STATE OF NORTH CAROLINA  
DEPARTMENT OF TRANSPORTATION

**Subject: Request for Modification and Renewal of the Section 404 Individual Permit and Section 401 Individual Water Quality Certification, and Catawba Riparian Buffer Authorization** for the Widening of NC 150 from the NC 16 Bypass in Catawba County to just west of the US 21/NC 150 Interchange in Iredell County, including the Interchange with I-77. Federal Aid Project No. STP-150(19), Division 12, TIP No. R-2307 and I-5717.

**References:** 1) Section 404 Individual Permit, Action ID No. SAW-2018-02343, issued September 3, 2020;  
2) Section 401 Individual Water Quality Certification and Catawba Riparian Buffer Authorization, NCDWR Project No. 20181732, issued April 17, 2019

PERMIT DRAWING  
SHEET 8 OF 22

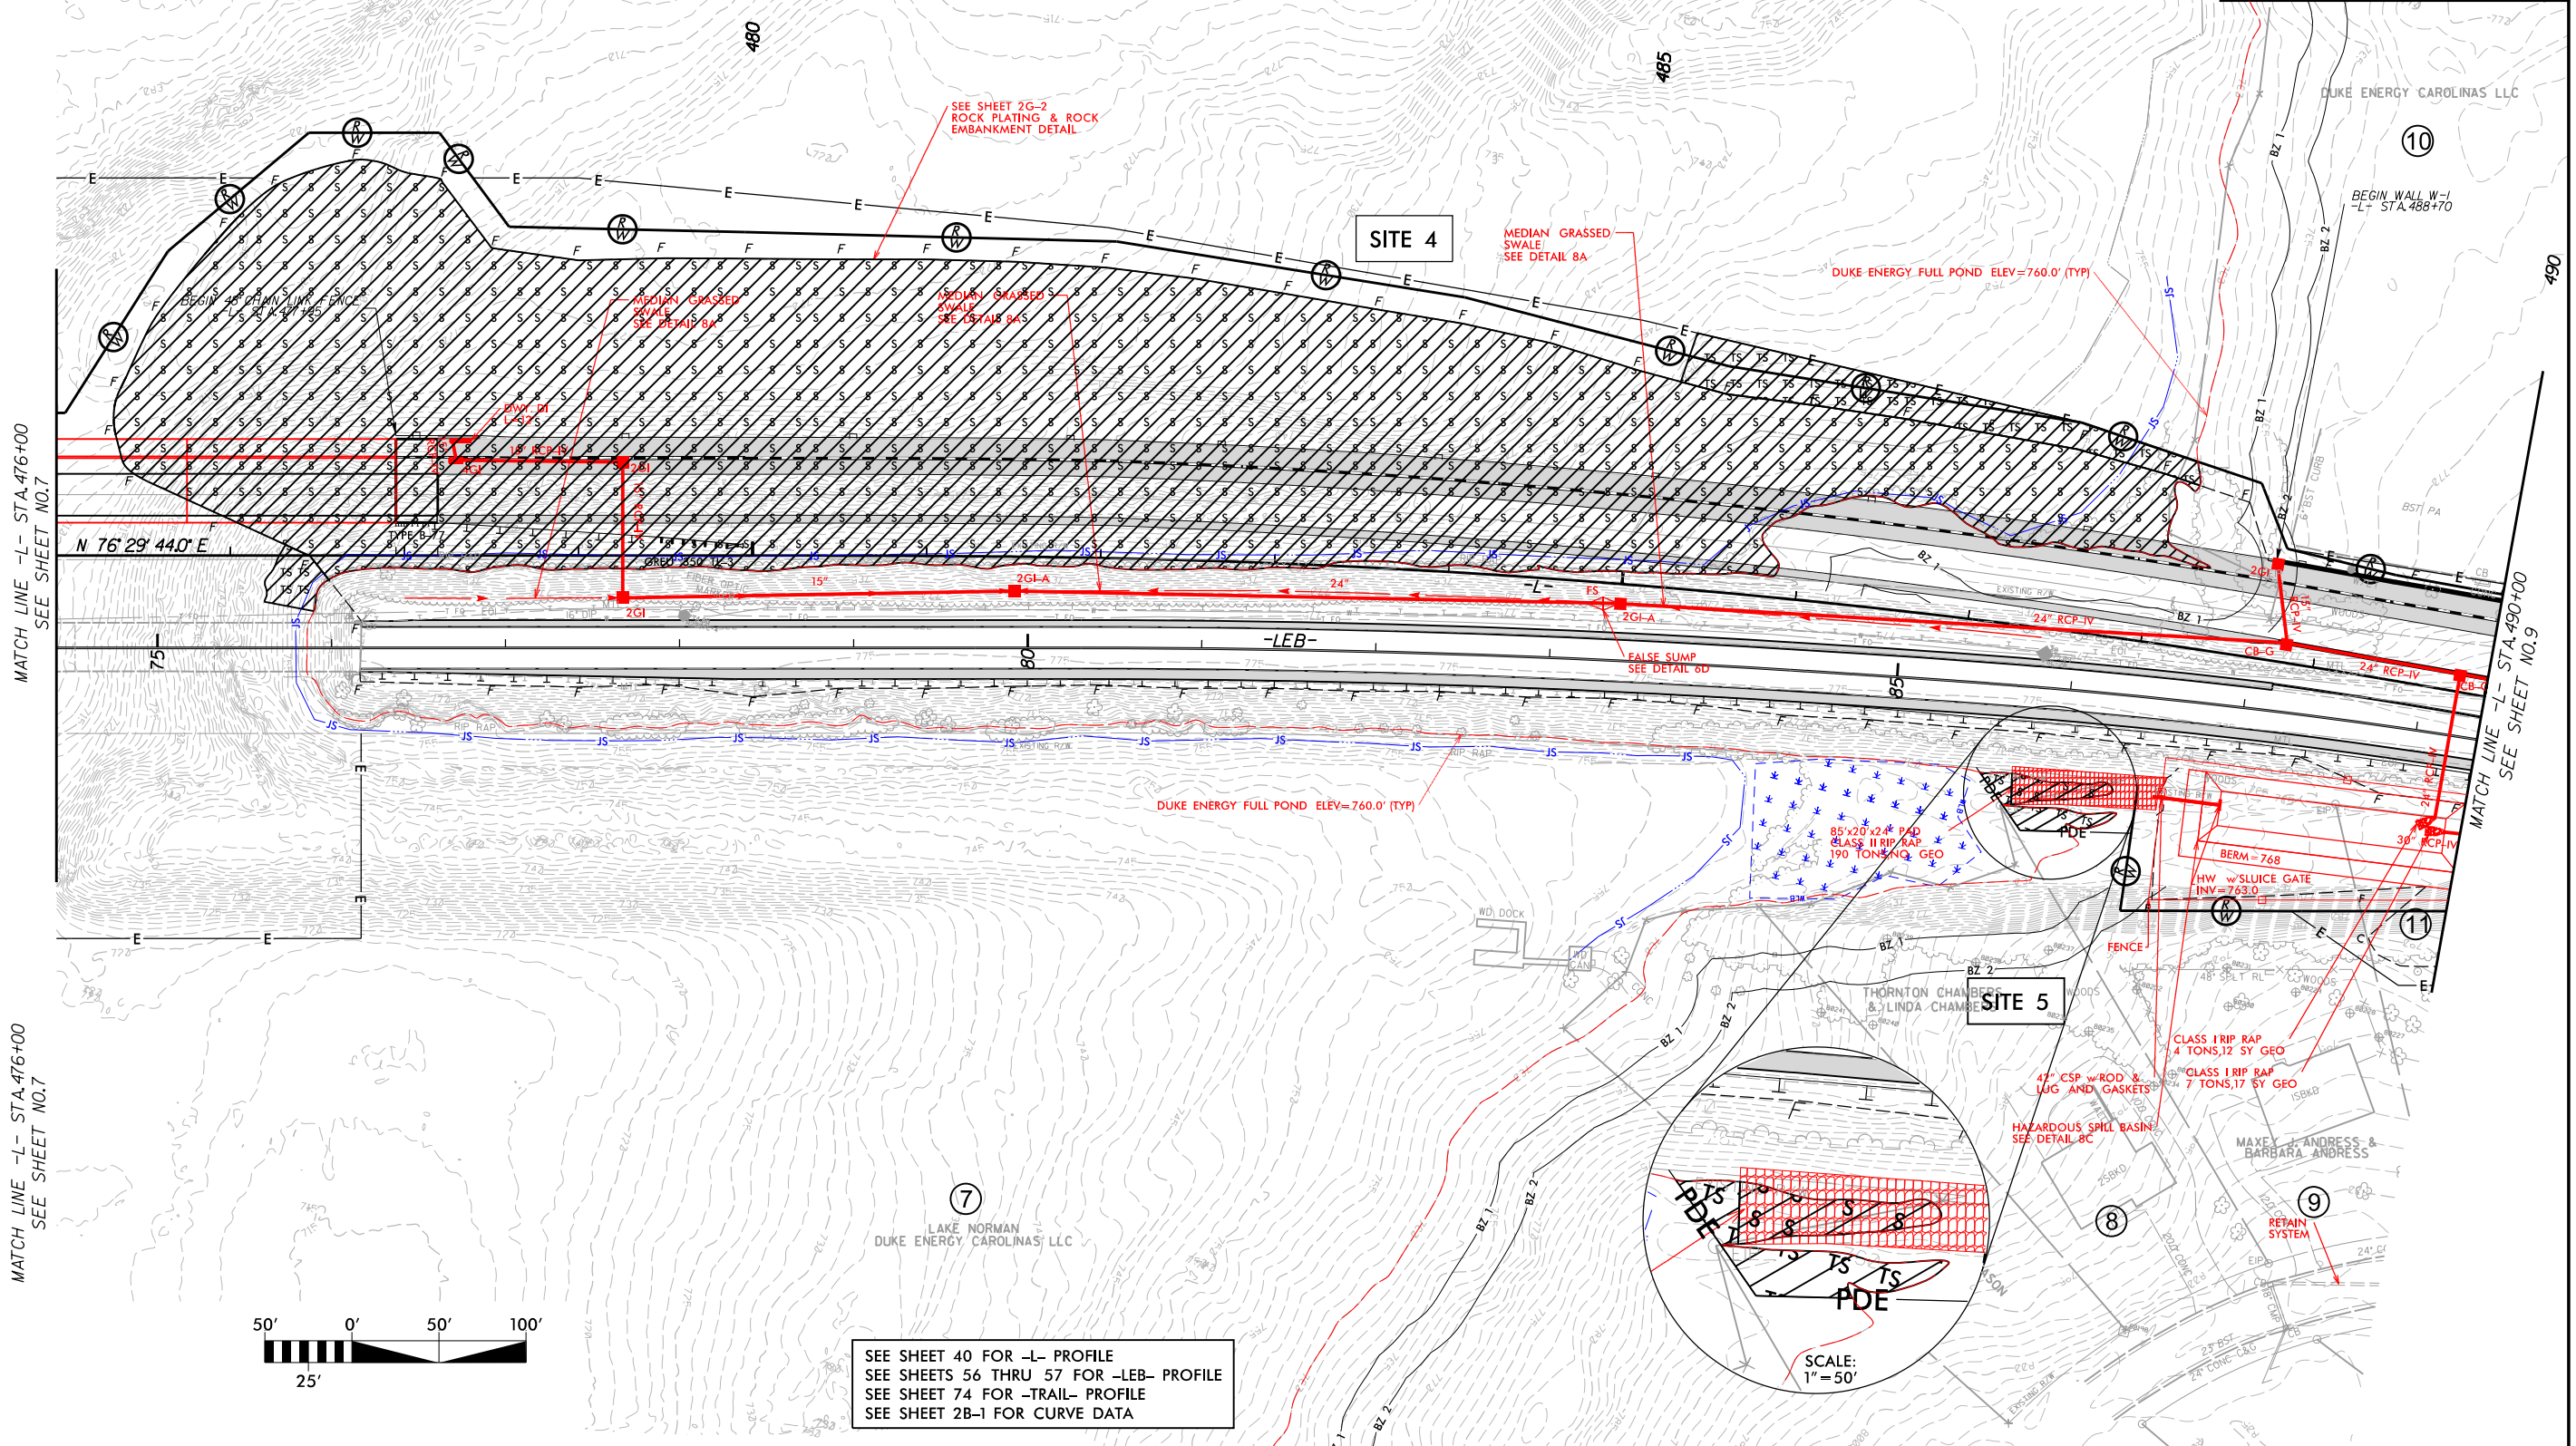
4. Site 4: Permanent Surface Water Impacts decreased from 3.91 acres to 3.859 acres due to minor slope changes at Lake Norman.
5. Site 4: Two temporary Surface Water Impacts were added down to elevation 750 ft on Permit Drawing Sheets 7-8. Temporary Surface Water Impacts increased from 0 to 0.162 acre.

PERMIT DRAWING  
SHEET 19 OF 22

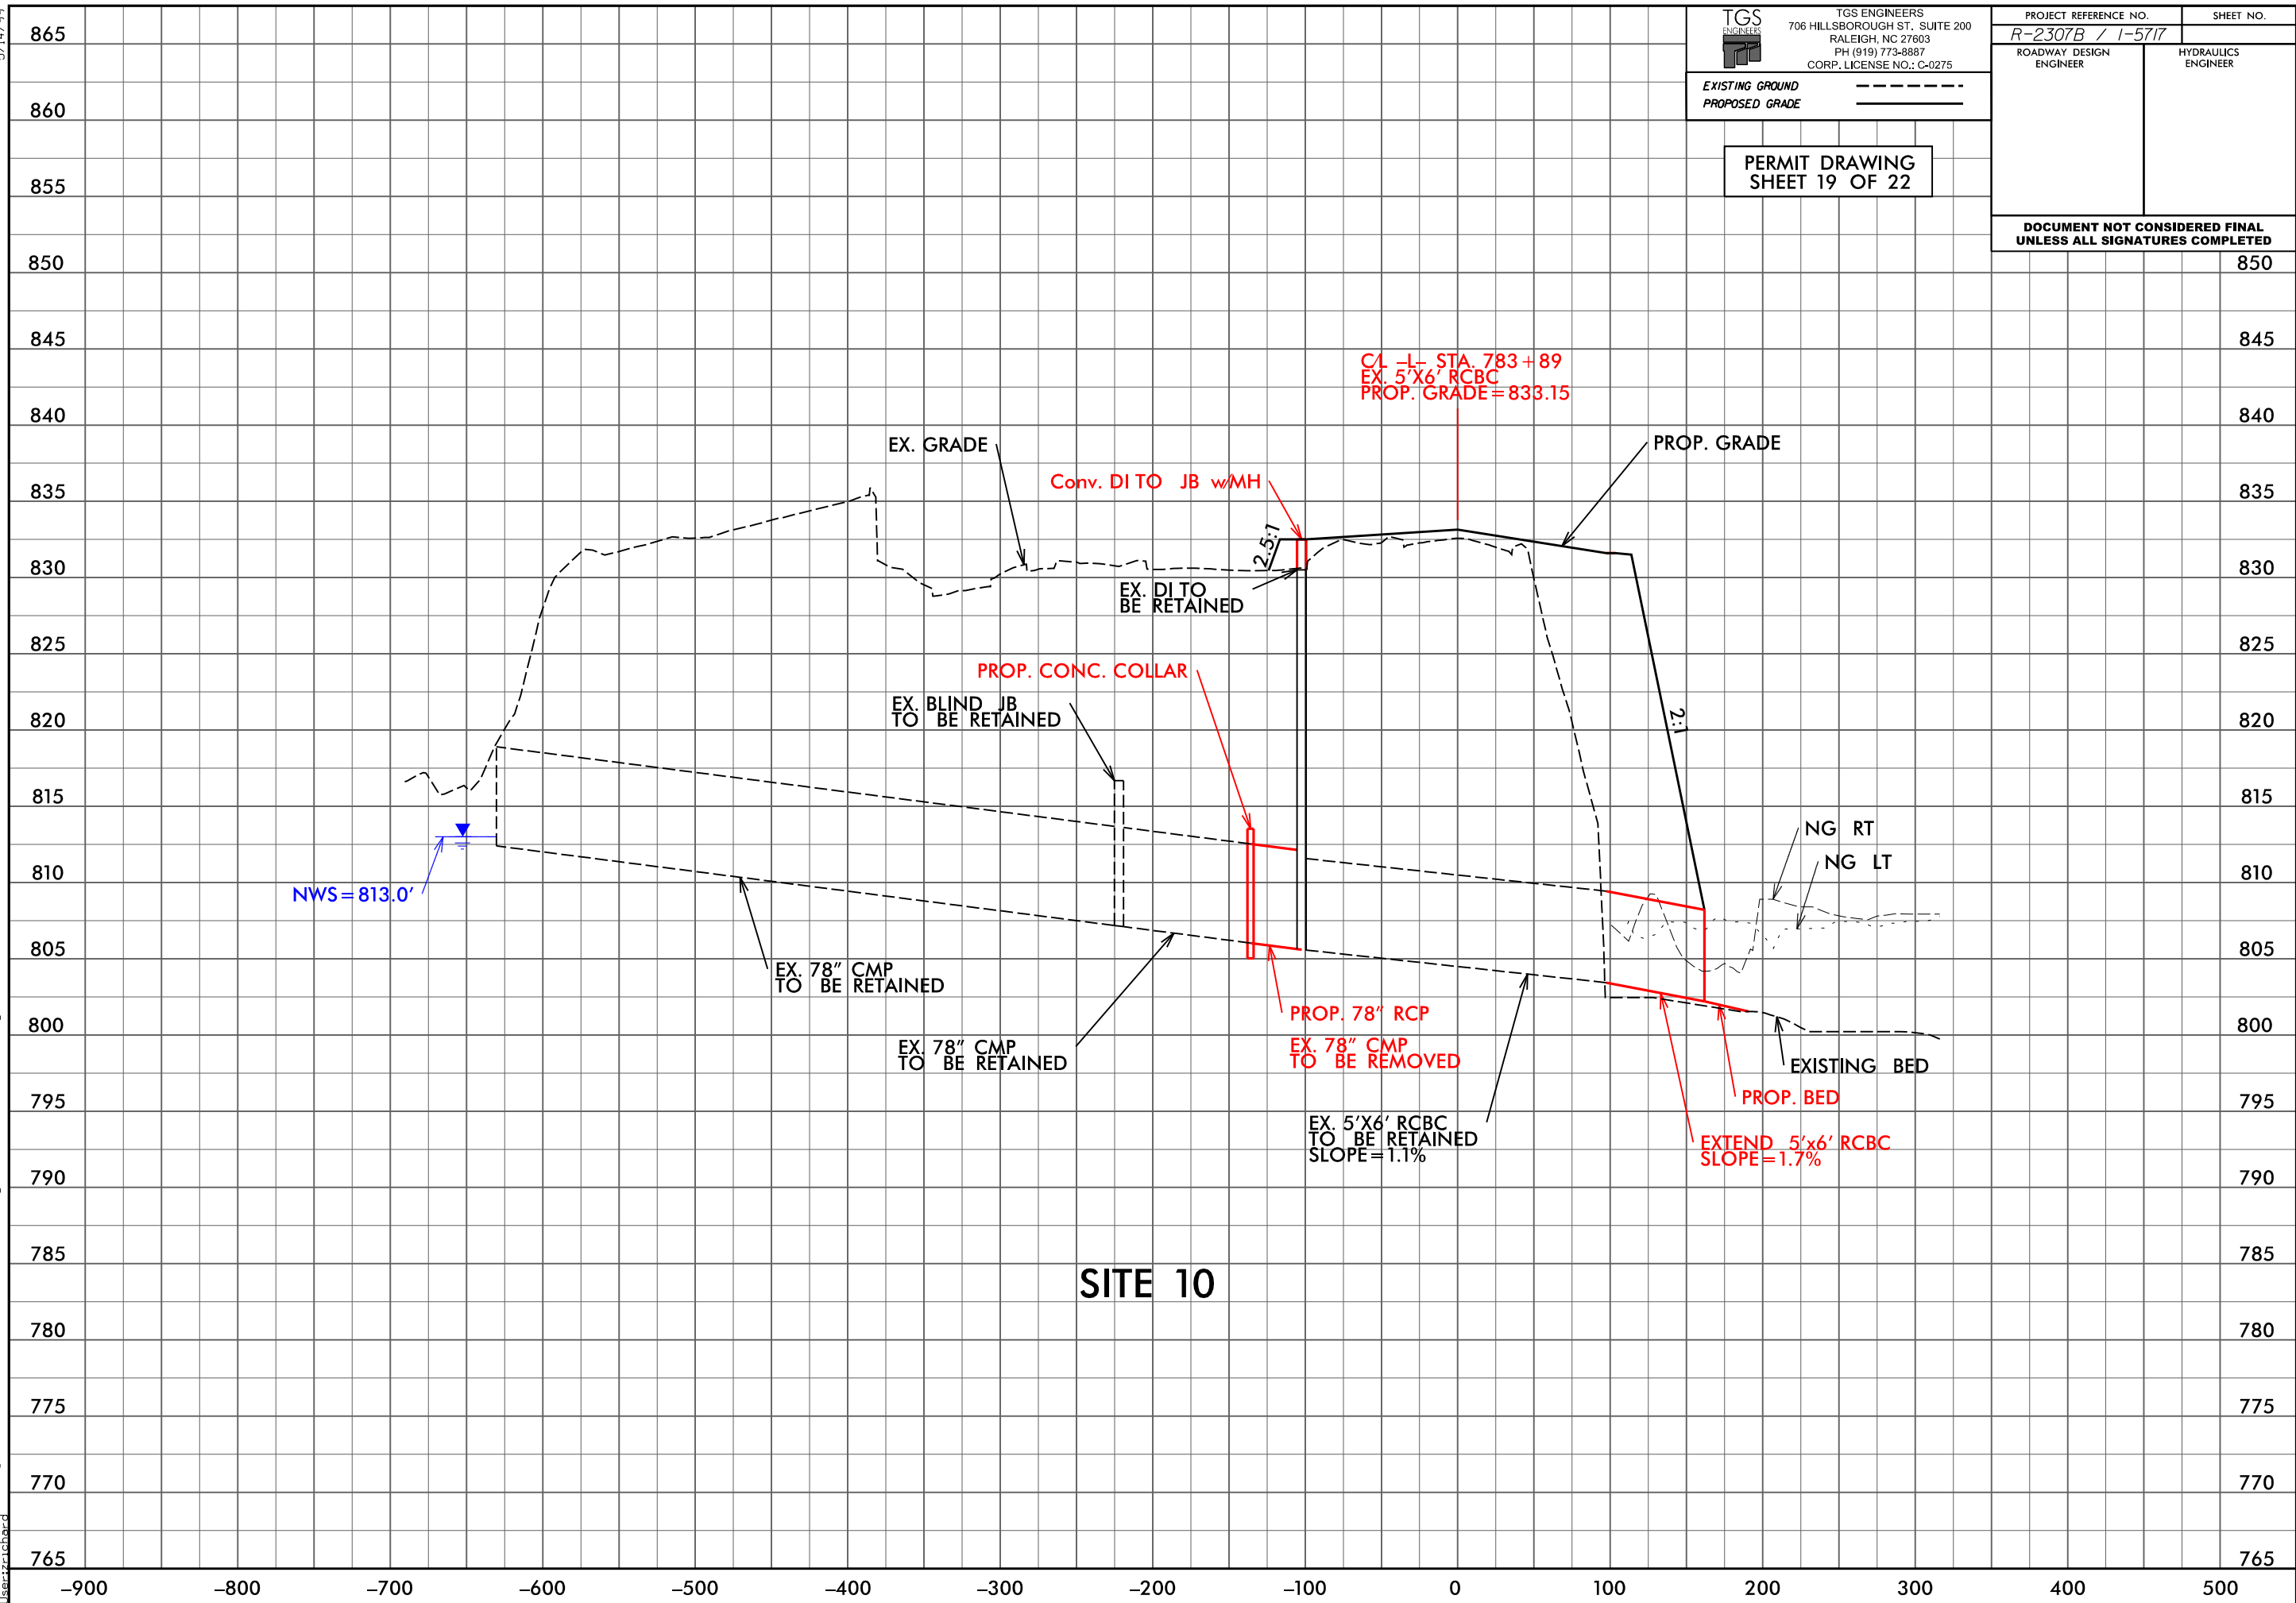
6. Site 10: The previous design proposed a 9' diameter precast manhole connecting an existing RCBC to a proposed 78" RCP at the downstream culvert extension at 784+50 RT (Permit Site 10). NCDOT determined that attaching a precast manhole to the existing RCBC is not feasible and would require a cast in place connection. To avoid this situation, the existing 5'W x 6'H RCBC will be extended. This will result in the outlet of the RCBC shifting 3' west of the previous 78" RCP outlet. However, the inverts, lengths, and channel layout will remain the same. There are no changes to stream impacts.
